RE: **Lot 16 Block 1 Volcano Cliffs Unit 22 SAD 228**
8011 Agua Fria Ct. NW
Grading and Drainage Plan
Engineers Stamp Date: 10/29/2020 (D10D003N16)
CO Certification Date: 6/15/2023

DRAINAGE AND TRANSPORTATION INFORMATION SHEET (REV 11/2018)

SUBMITTED FOR	SHEET TITLE	PROJECT NAME	DESIGNED BY DRAWN CHECKED BY DATE	REVISION
PAD CERTIFICATION	GRADING AND DRAINAGE PLAN	PETROGLYPH ESTATES 8011 AGUA FRIA CT PULTE ID 16	RESPEC <small>C Community Design Solutions ALL RIGHTS RESERVED © 2019 WWW.RESPEC.COM PHONE 800.255.7472</small>	
SHEET NUMBER:	STAMP SHELDON E. GREER REGISTERED PROFESSIONAL ENGINEER STATE OF CALIFORNIA NO. 17154 EXPIRATION DATE 03/31/2024			
1 OF 1

Asbuilt
LOT 16, BLOCK 1
VOLCANO CLIFFS UNIT 22

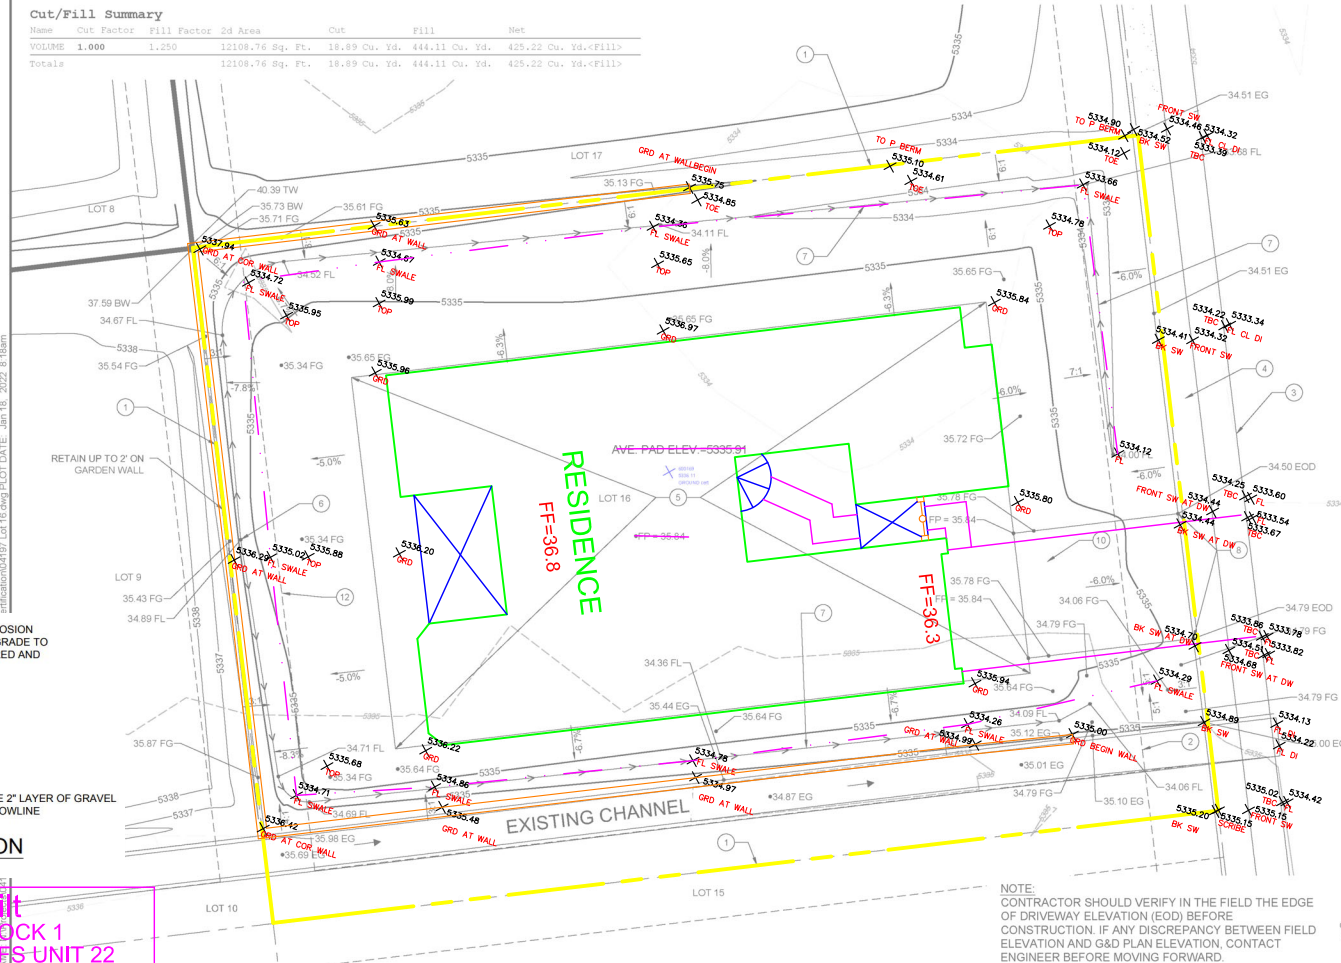
- The channel going from Alto Rey Ct to Agua Fria must be cleaned and free of debris.
